RESPONSES TO ACCOMPANY 25 APRIL RESUBMITTAL

RESPONSES TO ACCOMPANY 12 APRIL SUBMITTAL

SANCTUARY INTERSTITIAL DEVELOPMENT AND VIEWS BALLROOM EXPANSION

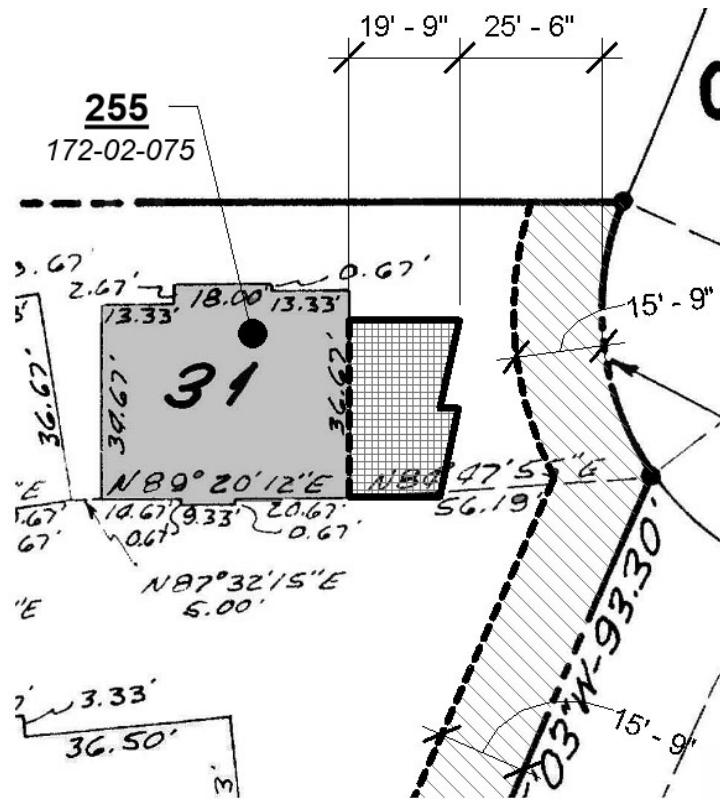
2.1) The existing parcel spacing precedent condition in the current SUP along a roadway is 15'-9" (established at hillside casita parcel 24 (172-02-068)). All proposed hillside casita improvements (as shown in hatched area) along Superstition Lane exceed the parcel spacing precedent condition.

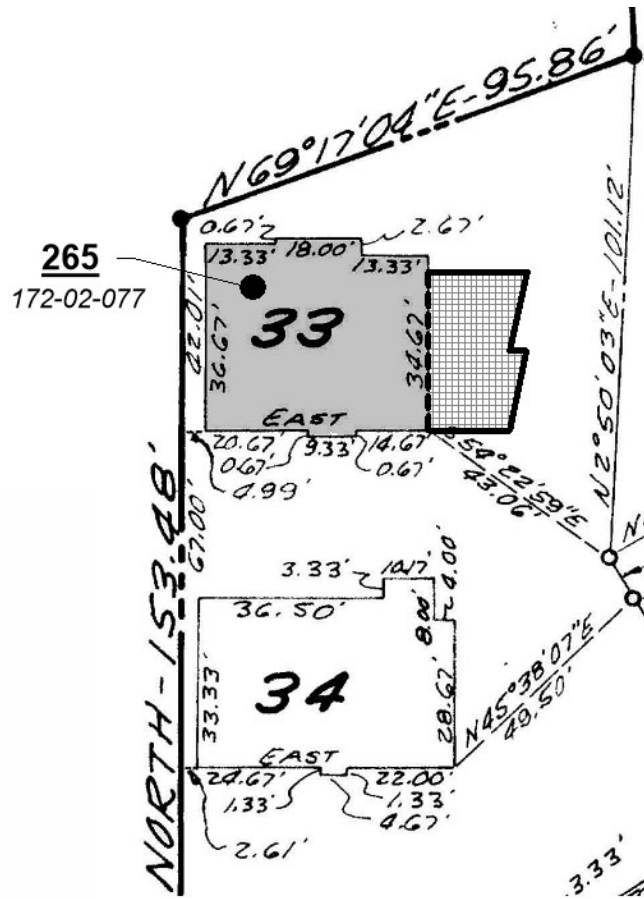
2.2) Hillside casita parcel 31 (172-02-075; Sanctuary Casita 255), lies well within the precedent condition under the current SUP. The proposed improvements are on the east side of the parcel. Currently there exists 45'-3" parcel spacing between the east property line and the Superstition Lane ROW. When the legal description of the parcel is amended to modify the footprint, there would remain a distance more than 25' between new property line and ROW, exceeding the 15'-9" of existing parcel spacing precedent.
